Co3237 Poultney BF 0145(13)

ADDENDUM #1

- Invitation for Bids, and Proposal to extend Bid Opening to June 13, 2025, and update the Schedule of Items.
- Special Provision Pages 1 and 6.
- Plan sheets 3, 10, 11, 44-52, 57, 63, 65, 79-82, 93, 94, 96, and 97.
- New Impact Plans shall replace Pages 136 to 171 in the Proposal.

PROJECT NAME:	POULTNEY	PLOT DATE:	5/19/2025
PROJECT NUMBER:	BF 0145(13)	DRAWN BY:	N.A. TRUSLOW
FILE NAME:	z21j164stringer.dgn	CHECKED BY:	J.D. KEENER
PROJECT LEADER:	J.D. KEENER	SHEET	49 OF 115
DESIGNED BY:	N.A. TRUSLOW		
STRINGER DETAILS

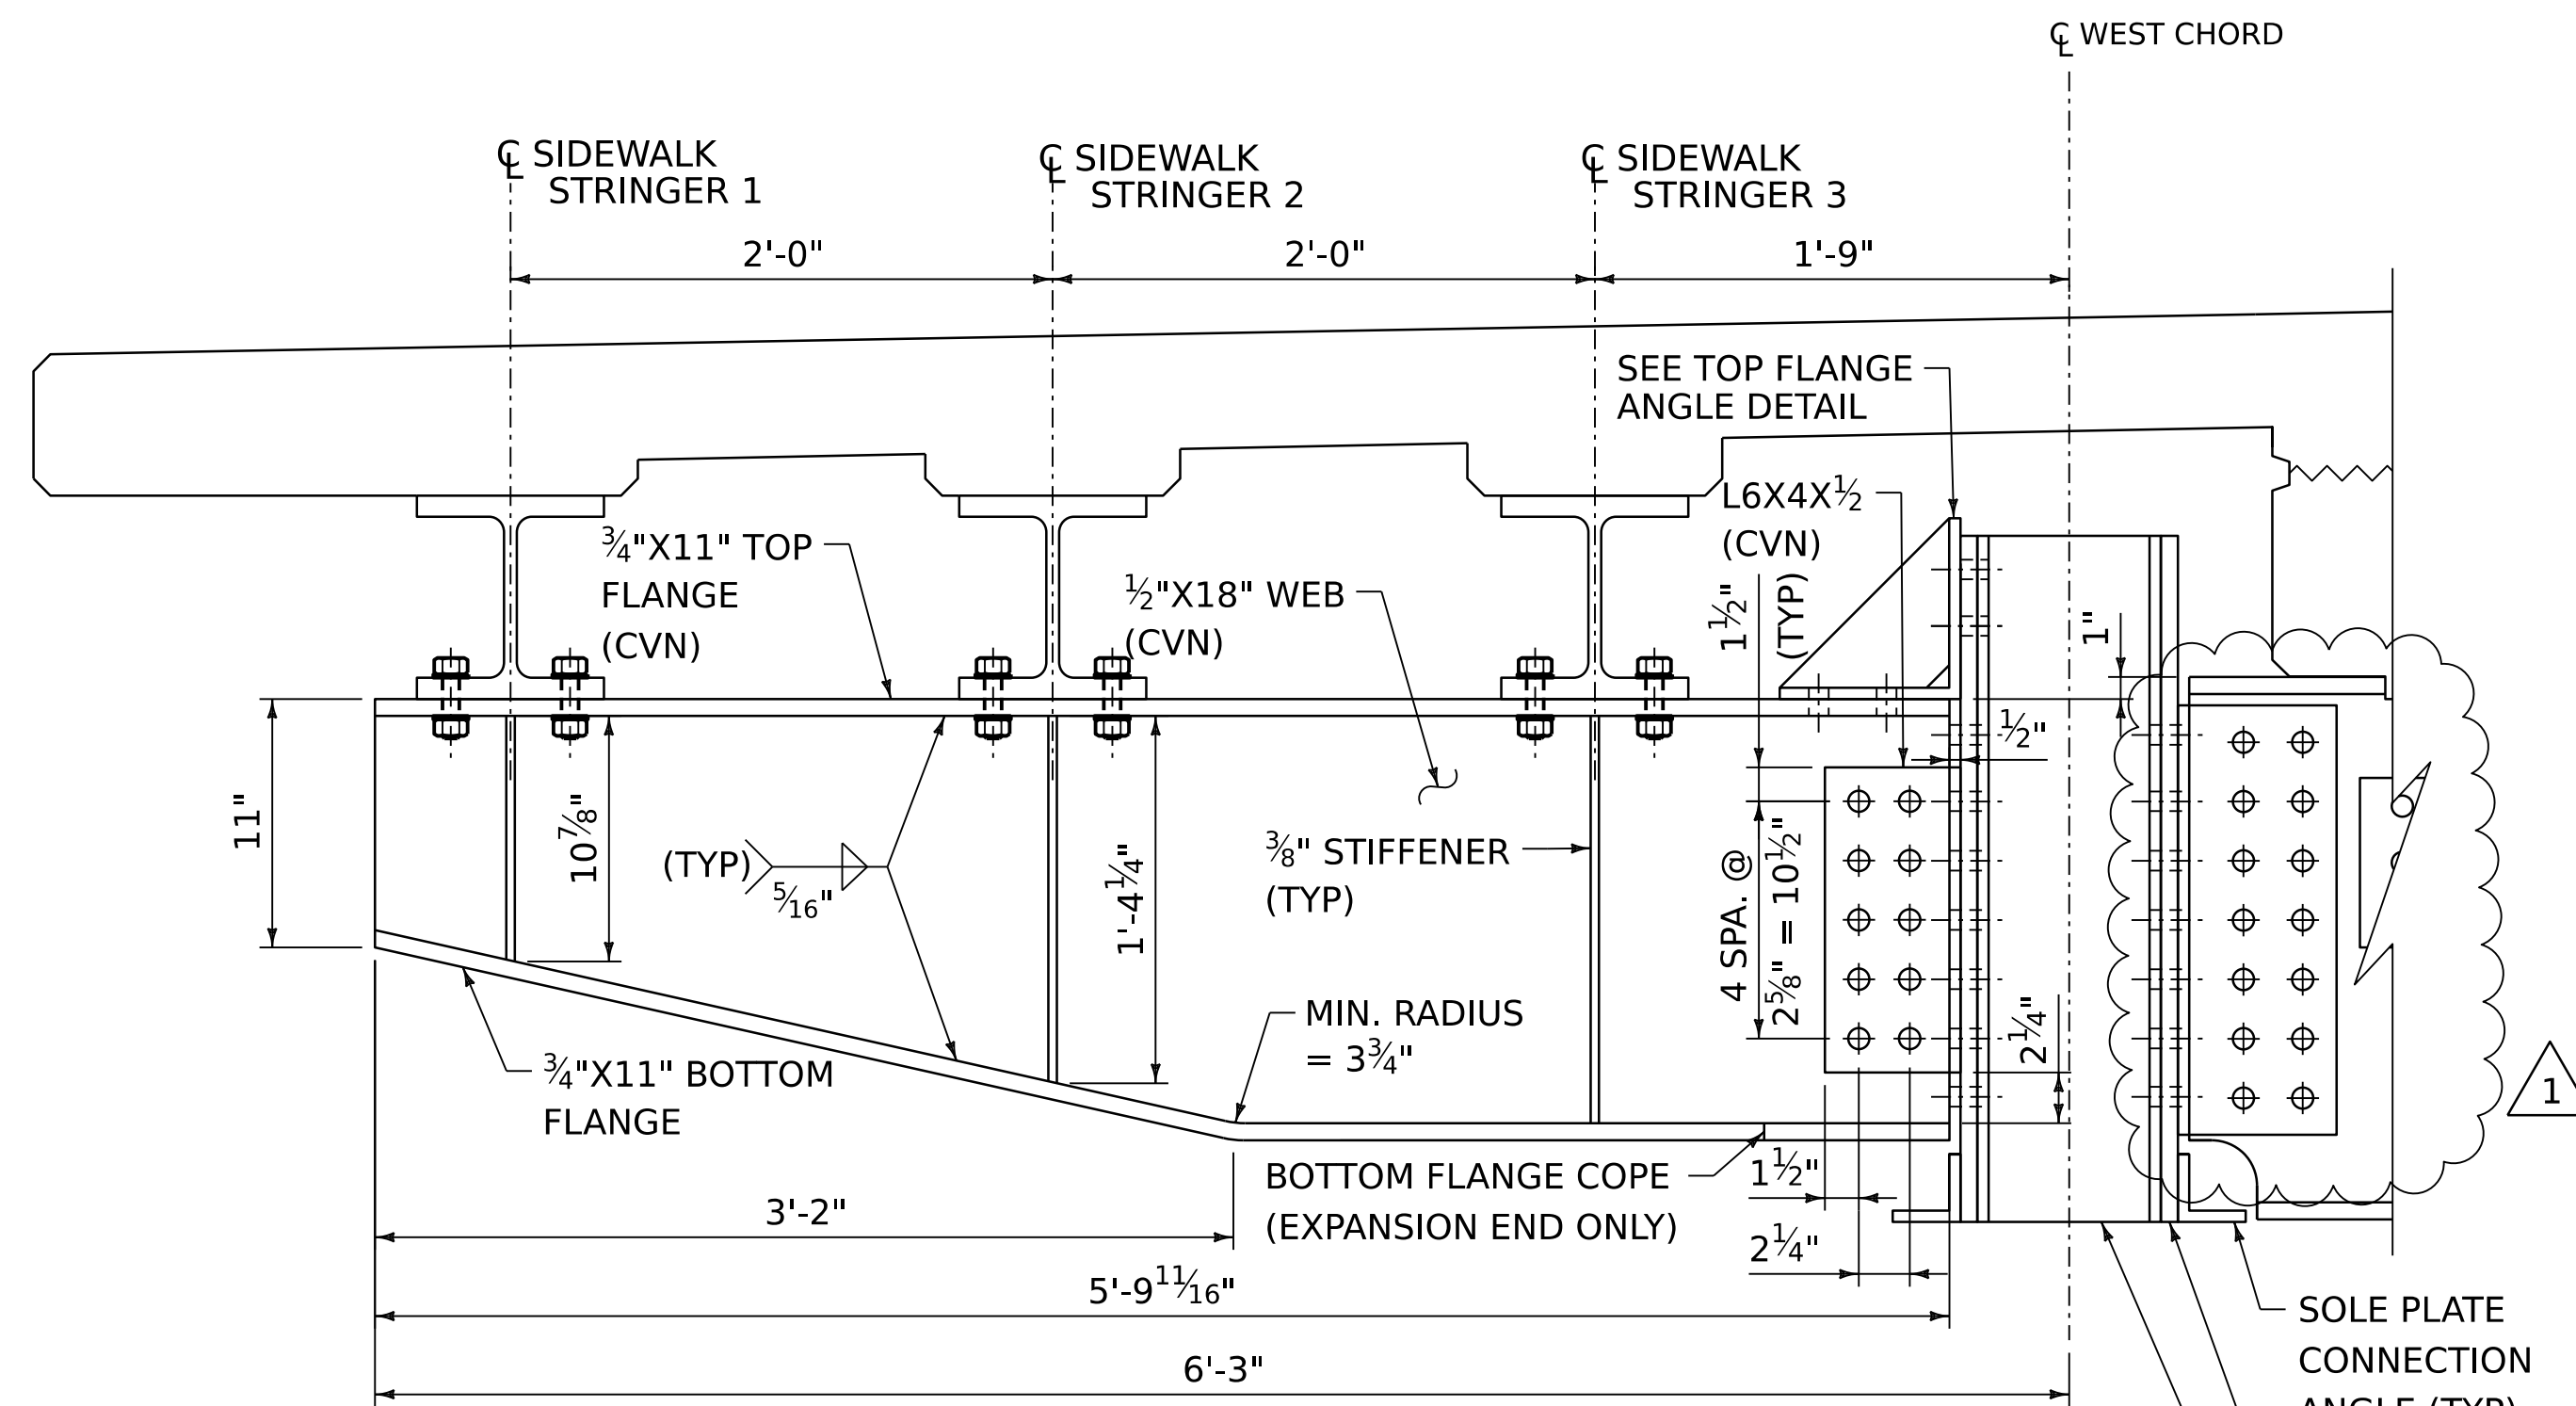
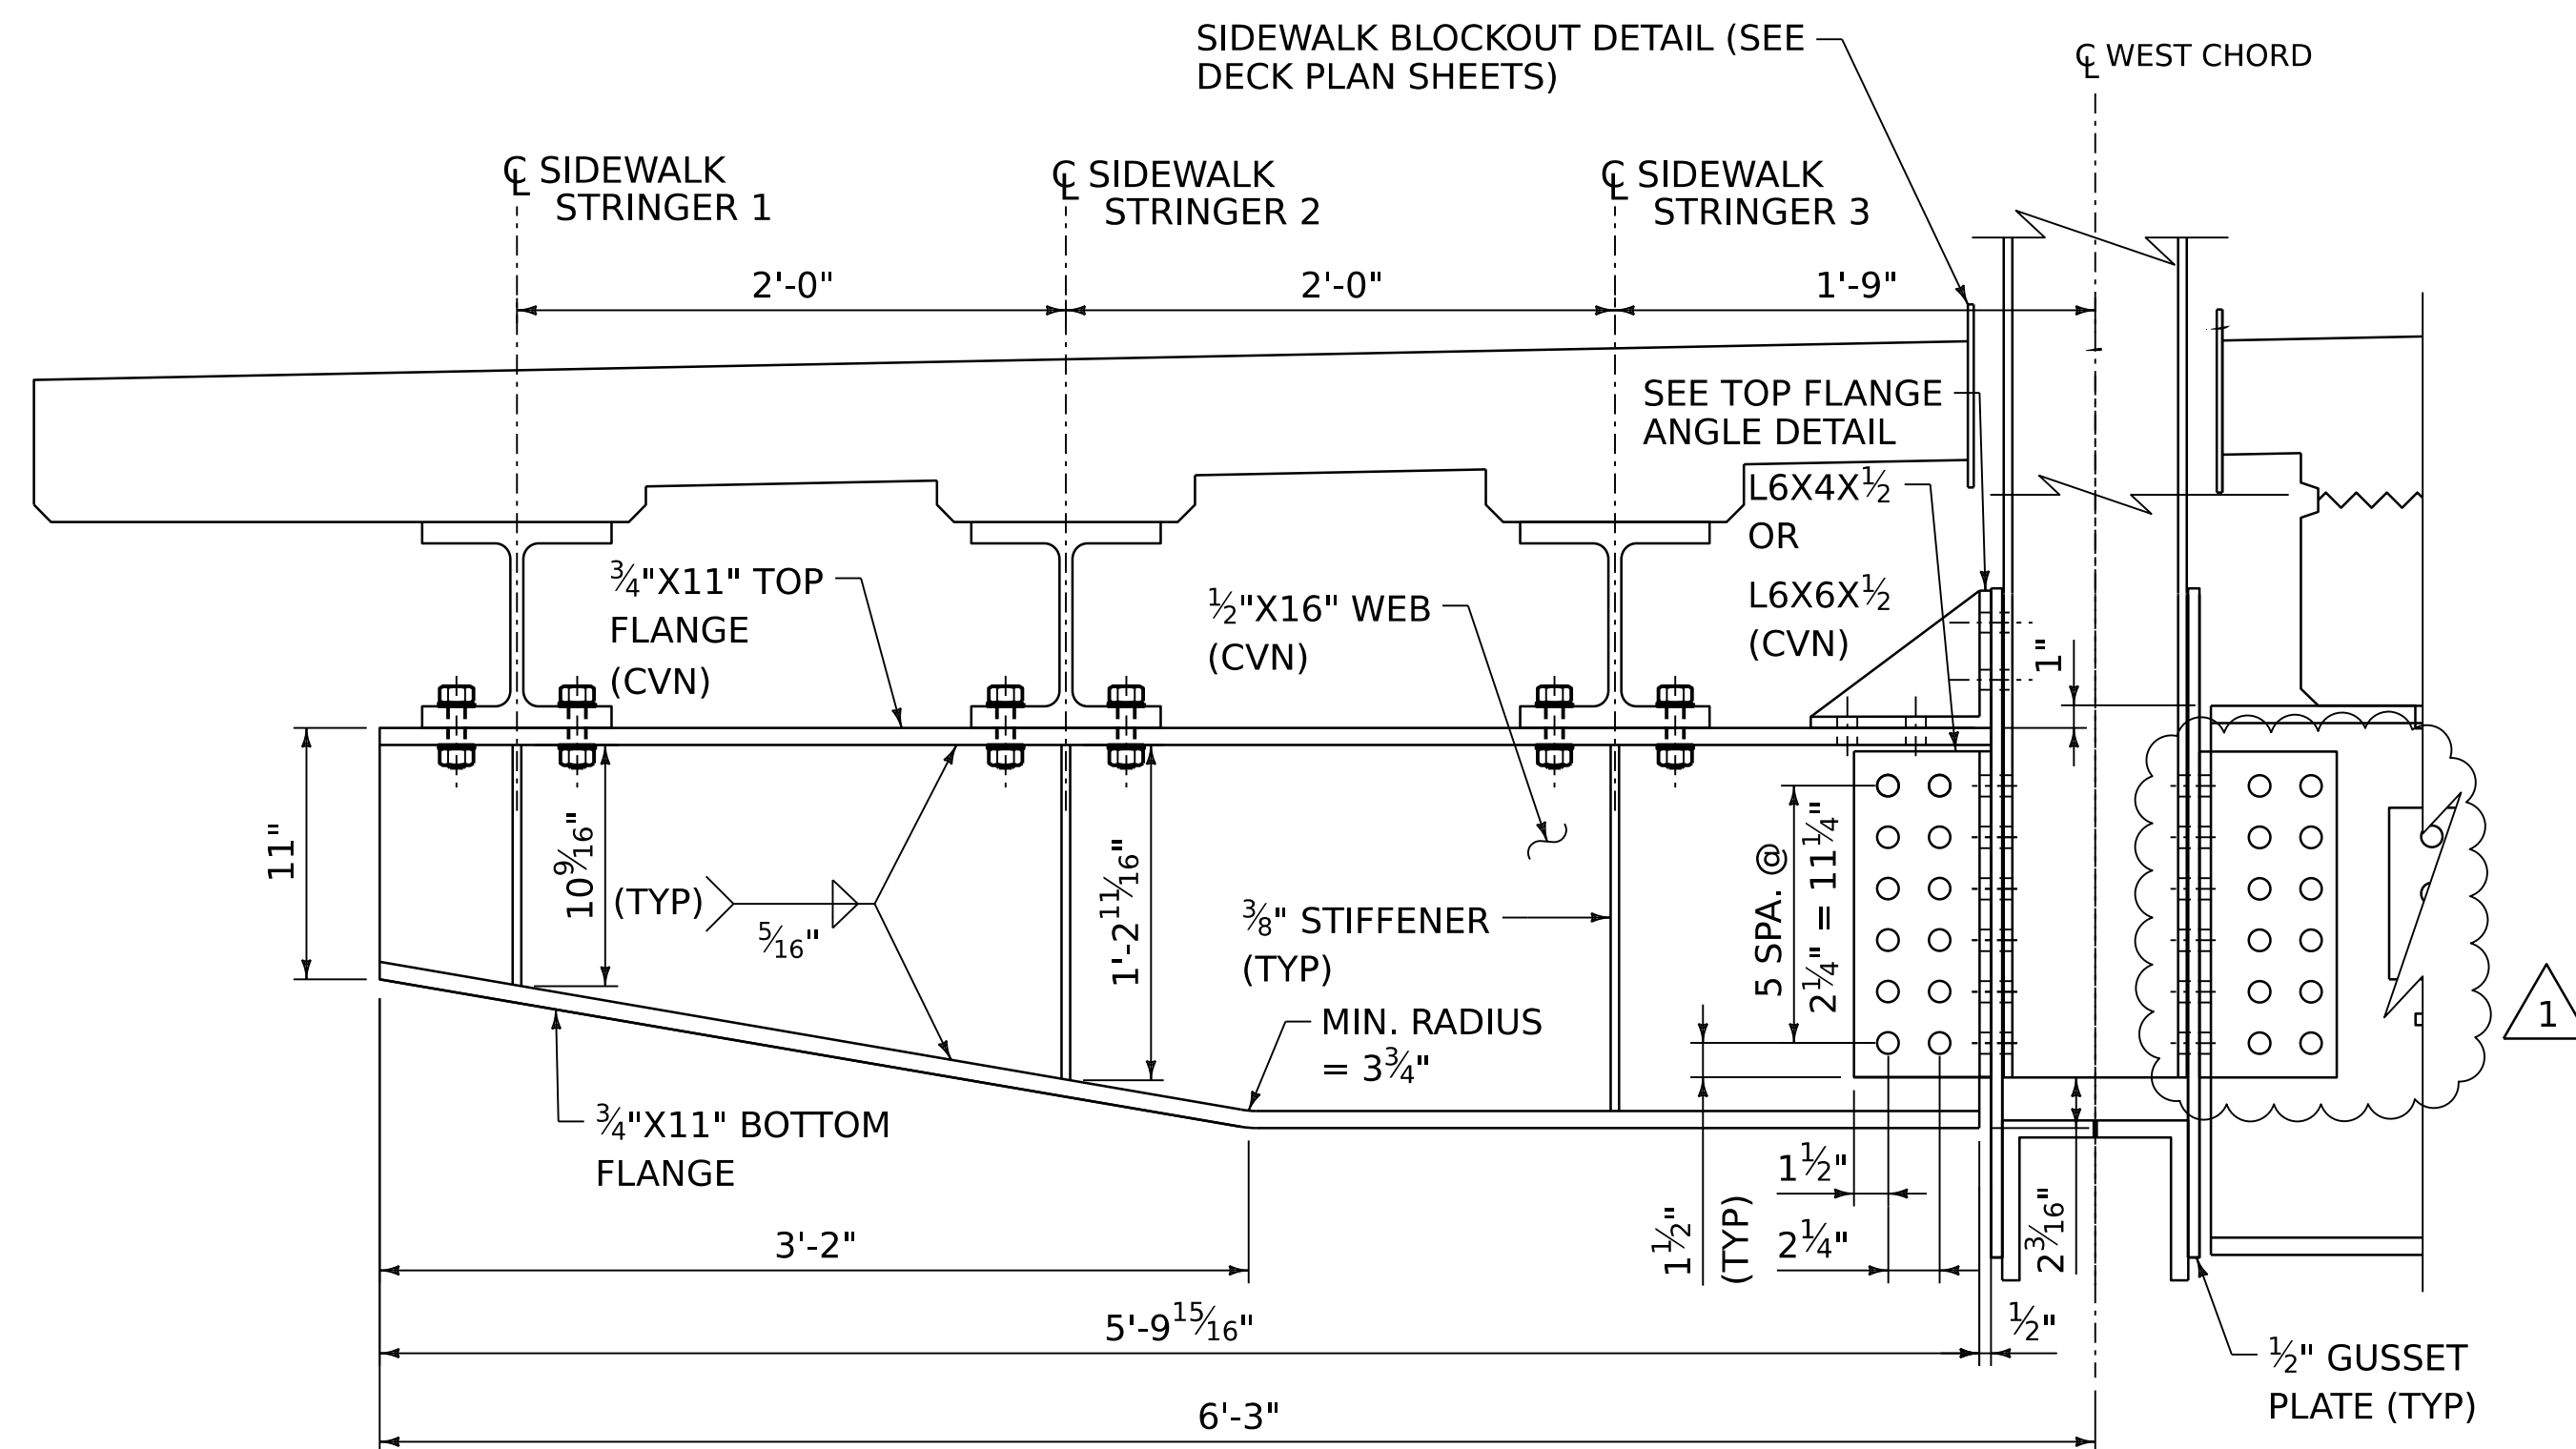
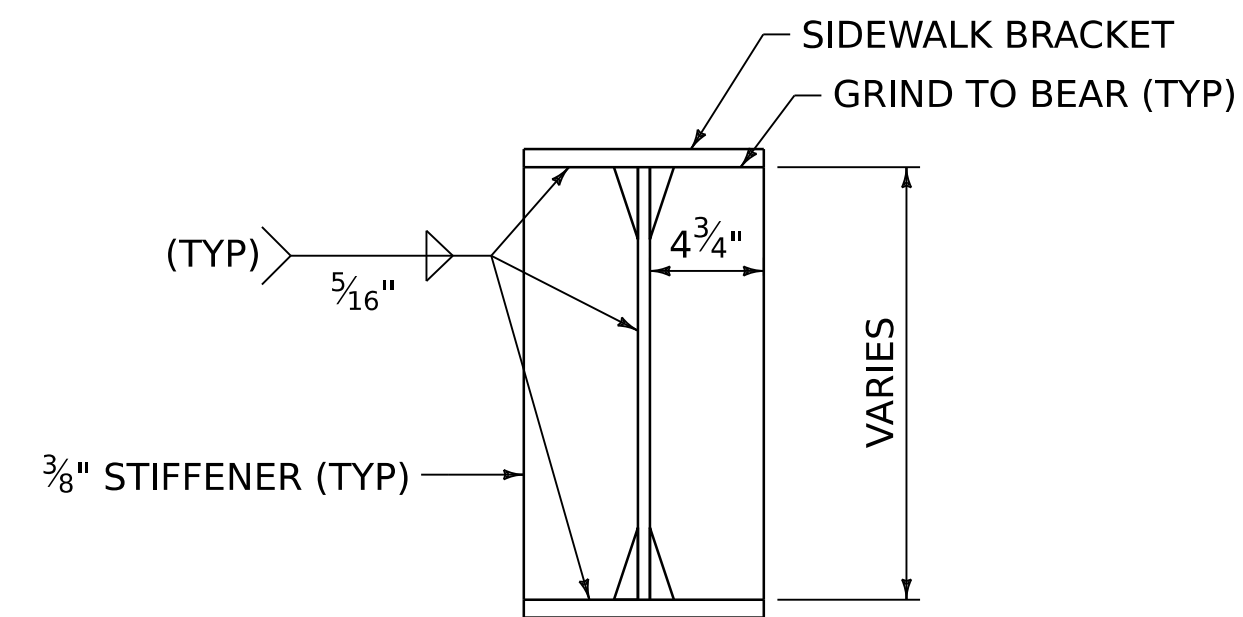
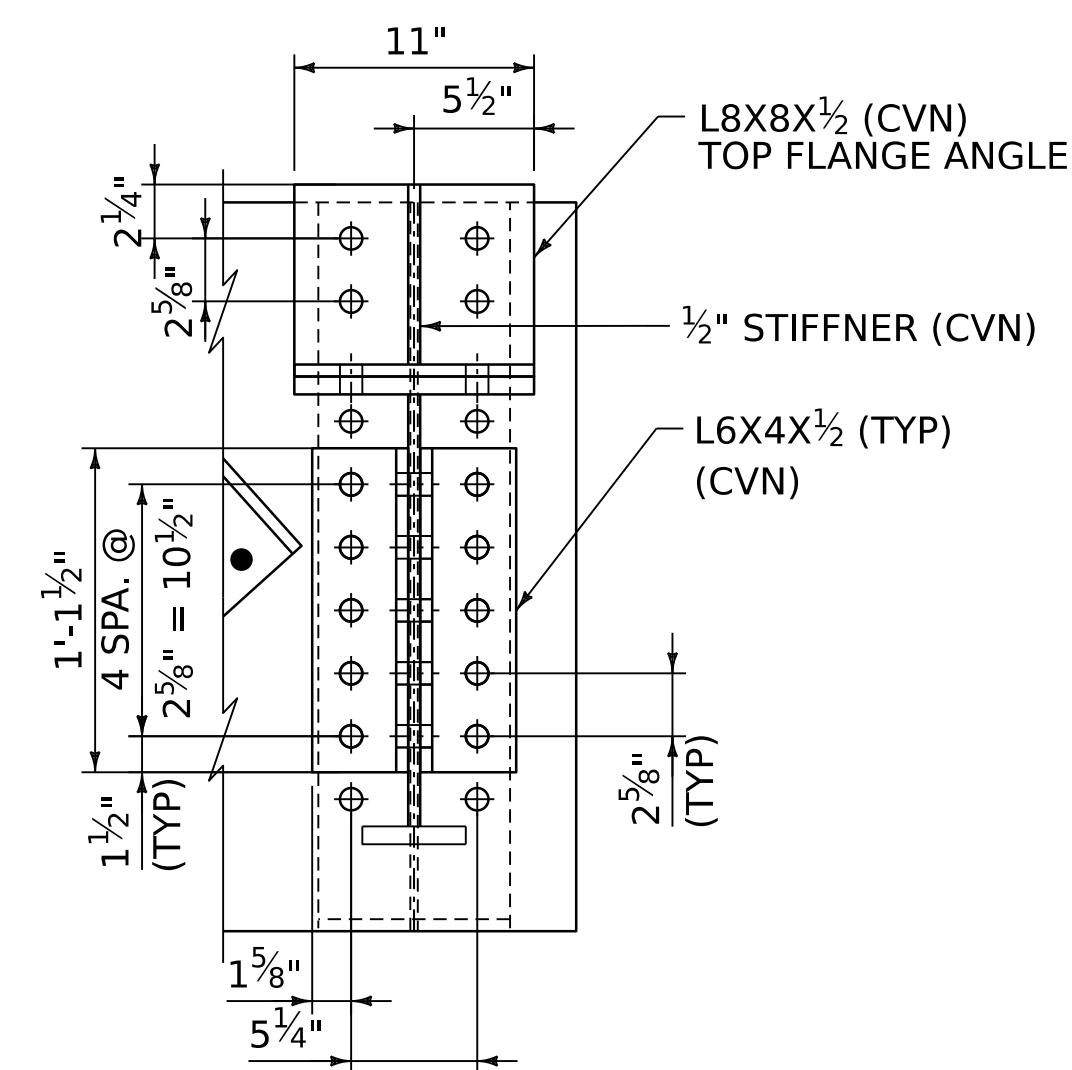
ADDENDUM	REVISION	PLOT DATE	DESCRIPTION	BY
1	1	5/19/2025	REVISED STRINGER CONNECTIONS AND SHEAR STUDS	NAT
